**RE: BEK Distribution Facility – 601 Gallatin Pl. NW
G&D Plan and Drainage Report Engineers Stamp Date: 6/25/2019,
Hydrology File: FJ10D002G1**

Based on the information provided in your submittal received on 6/25/2019 the Conceptual Grading and Drainage Plan and report cannot be approved.

**RE: BEK DISTRIBUTION FACILITY – 601 GALLATIN PL. NW
G&D PLAN AND DRAINAGE REPORT ENGINEERS
STAMP DATE: 05/16/2019, HYDROLOGY FILE: FJ10D002G1**

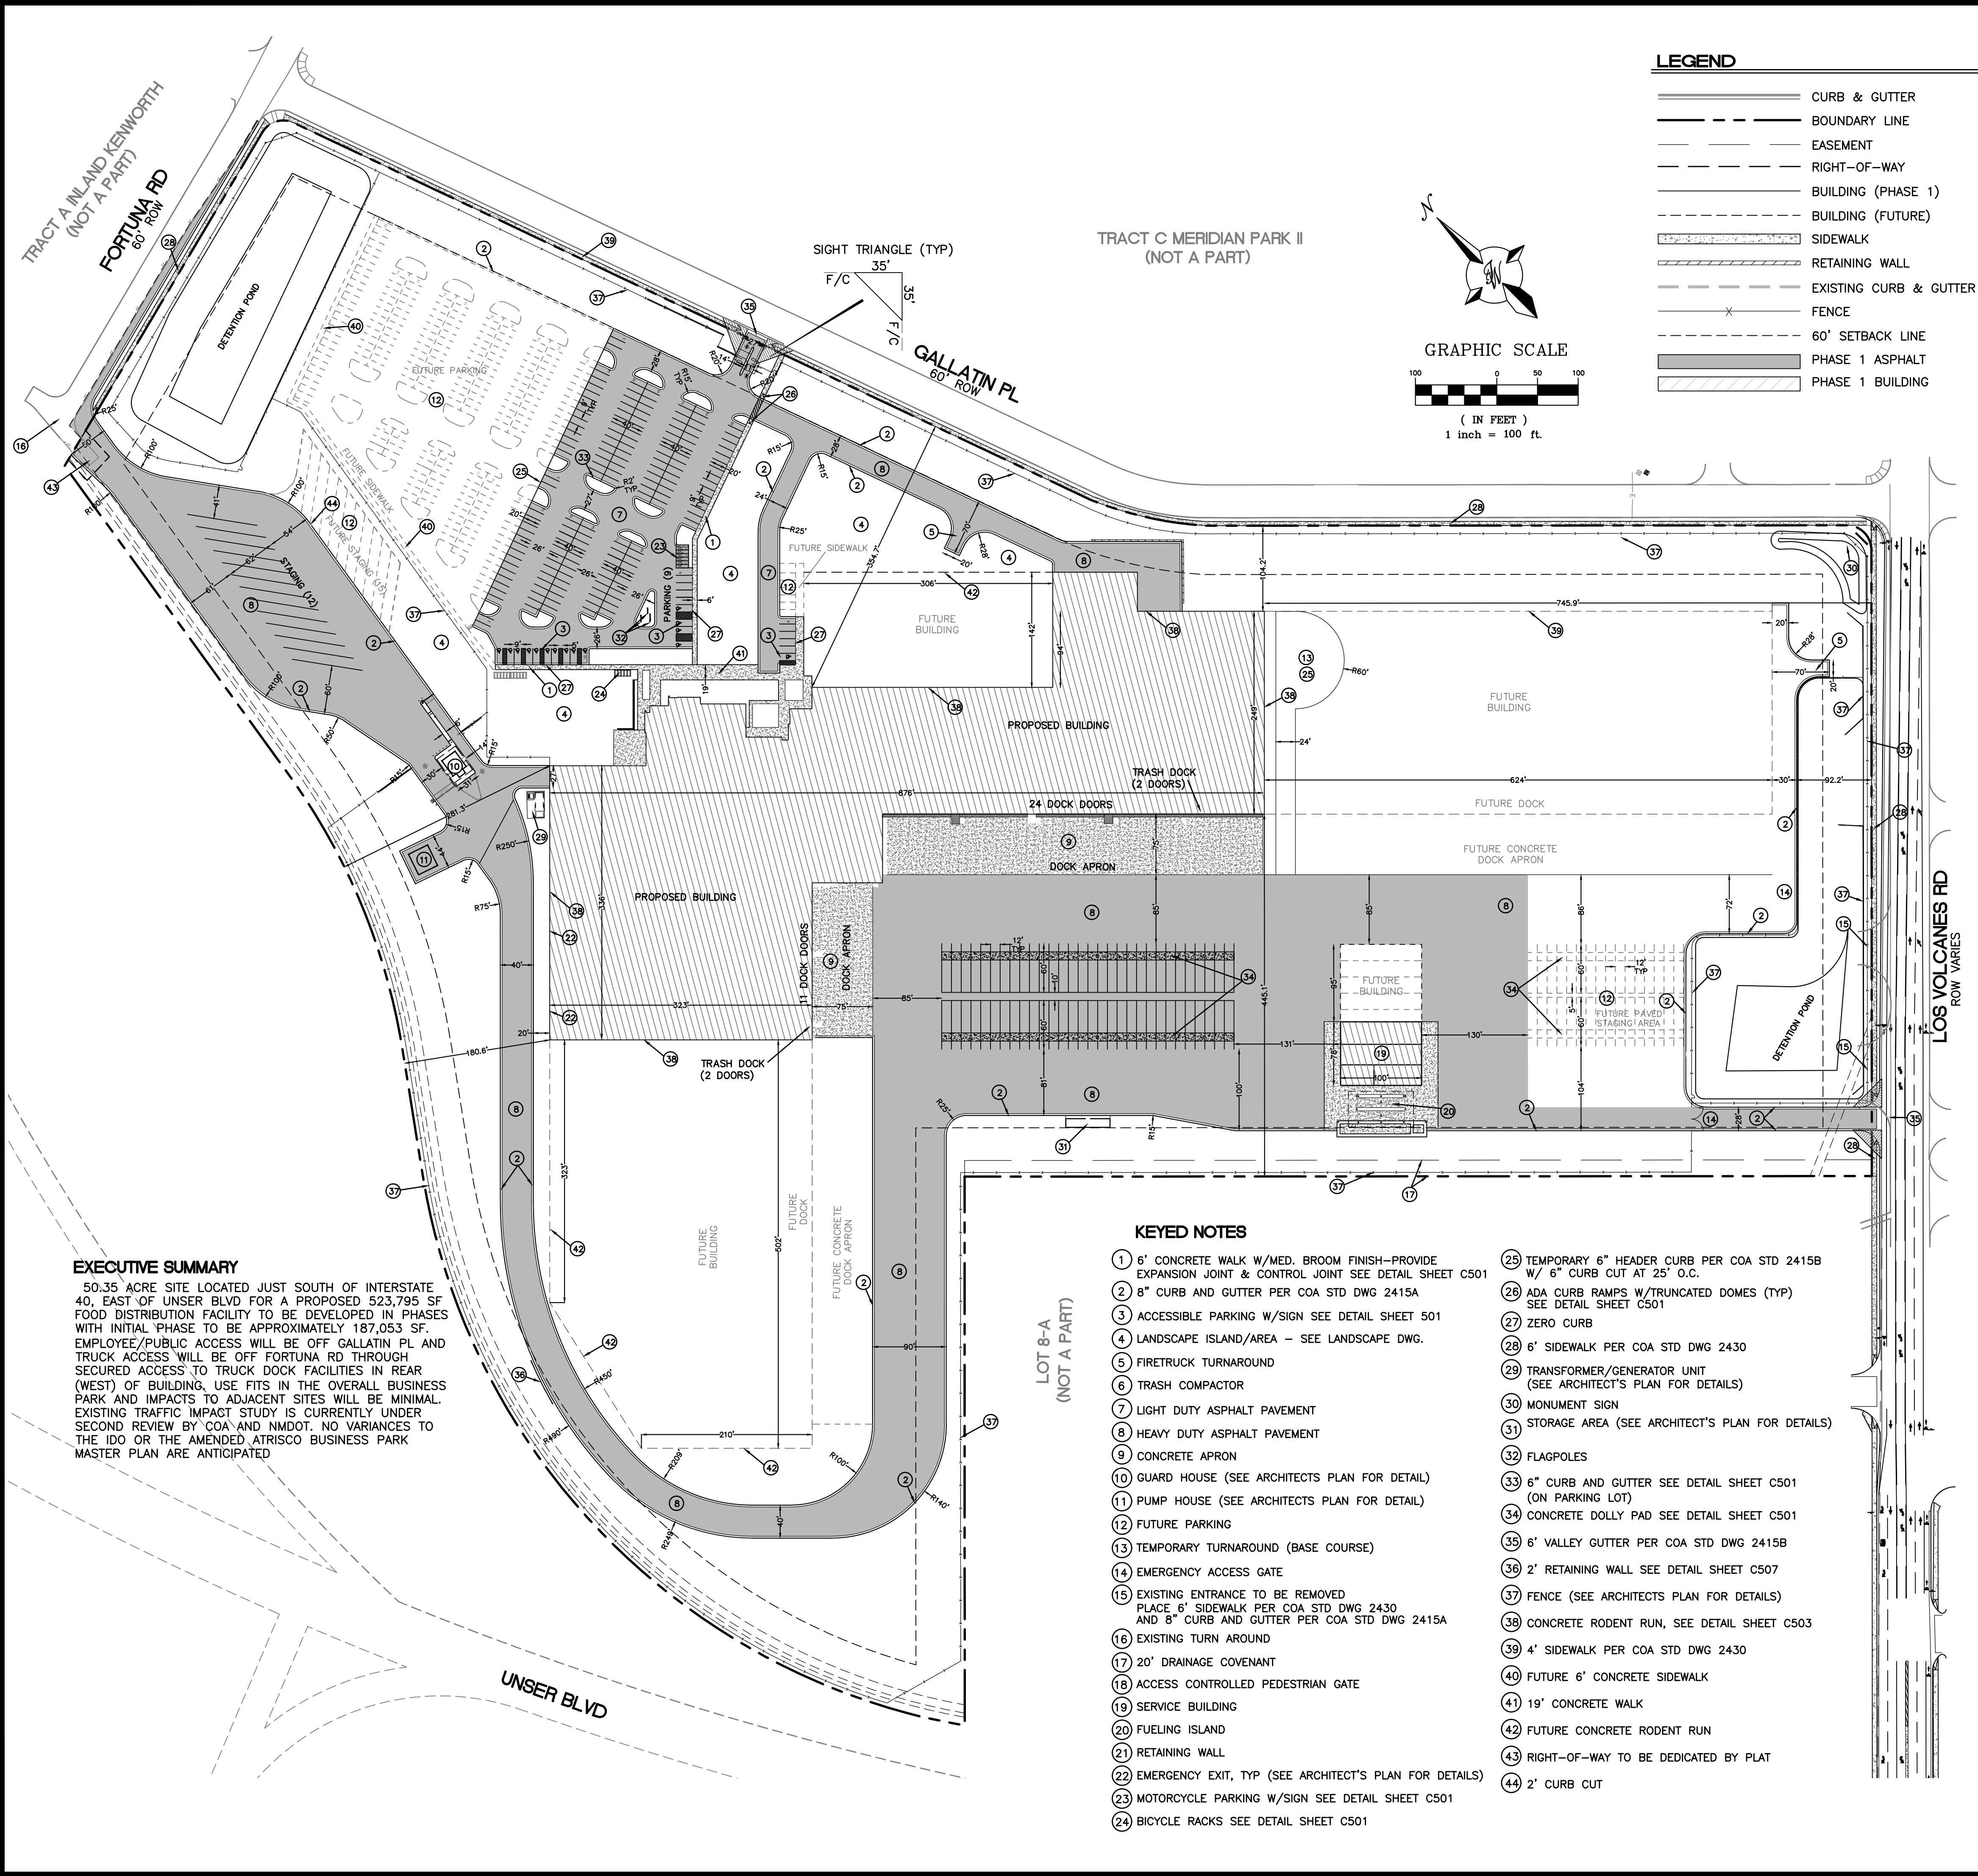
2. Please revise the Pond volume calculations in the report to show that Basins 31 and 32 drain to pond 4 and revise the Direct Discharge calculation.
3. Also please add a calculation of the required SWQV and a statement of how that volume is being provided as note 3 on Sheet C201.

C101
CIVIL

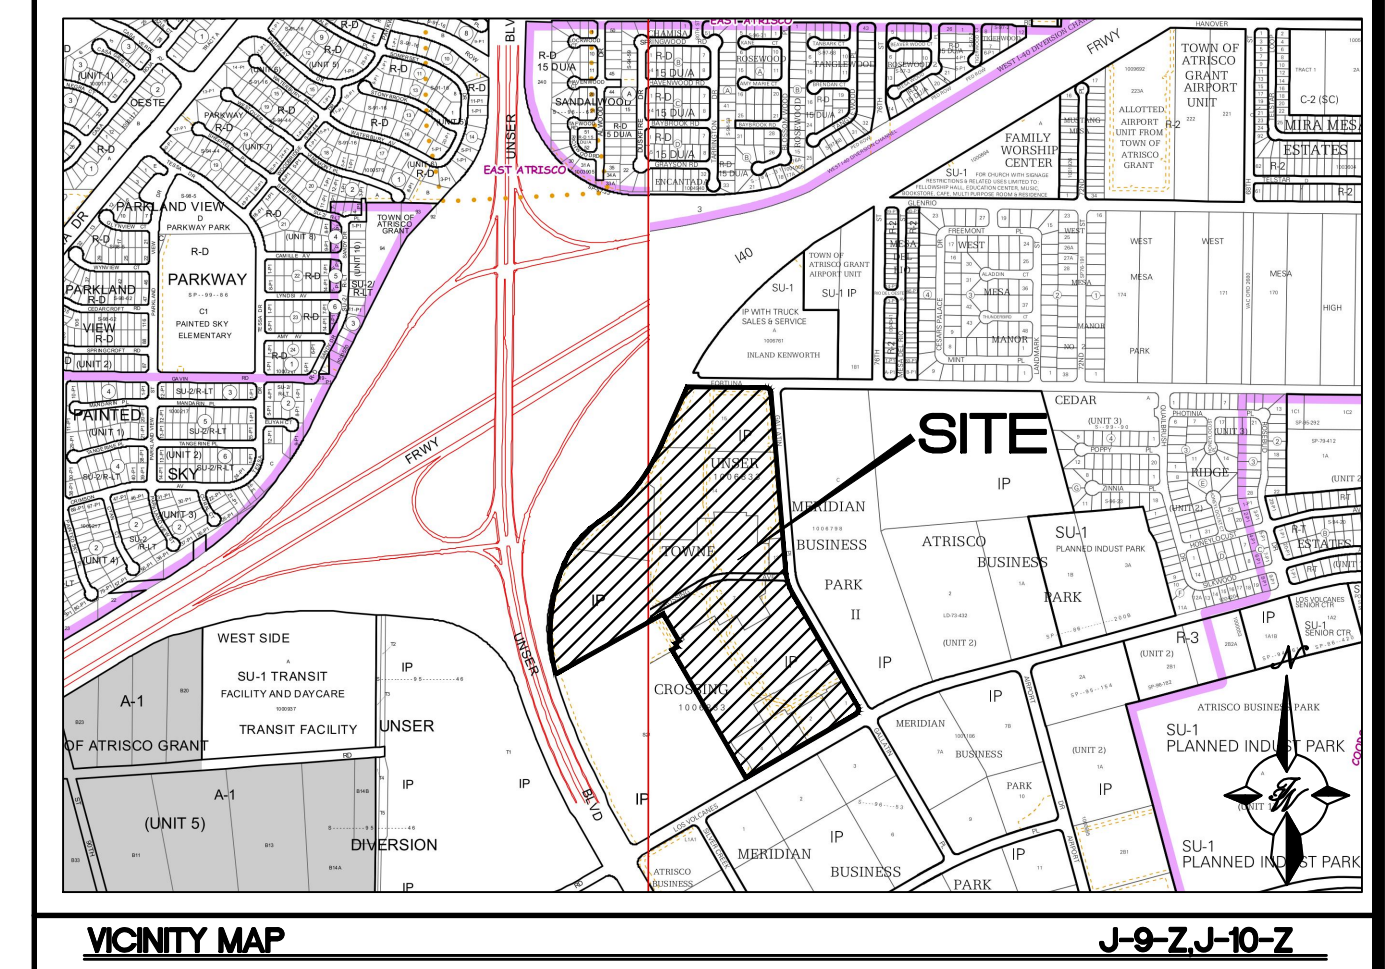
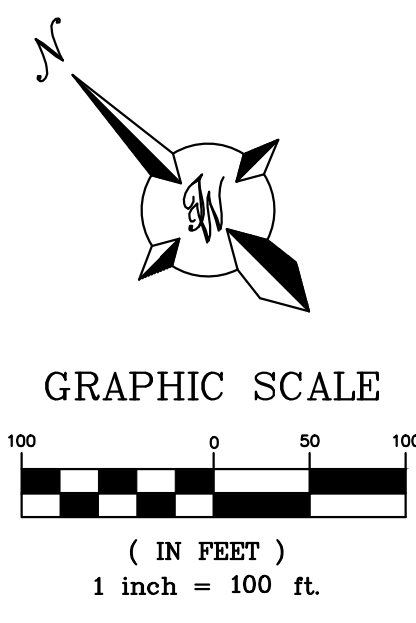
7. Key note 25 on the Site Plan calls for a 6" temporary header curb that is not shown on the G&D Plan. Please revise one or the other so they agree, and provide a copy of the revised Site Plan when resubmitting to hydrology. If the temporary curb is to remain please add details of the curb on the G&D Plan with spot elevation that show how the parking lot will drain thru the curb.

5. Key note 25 on the Site Plan calls for a 6" temporary header curb that is not shown on the G&D Plan. Please revise one or the other so they agree, and provide a copy of the revised Site Plan when resubmitting to hydrology. If the temporary curb is to remain please add details of the curb on the G&D Plan with spot elevation that show how the parking lot will drain thru the curb.

Response: The 6" curb is needed to deter traffic from using the future phase area. Grading plan note has been modified to include curb cuts to allow drainage to follow intended path to pond.
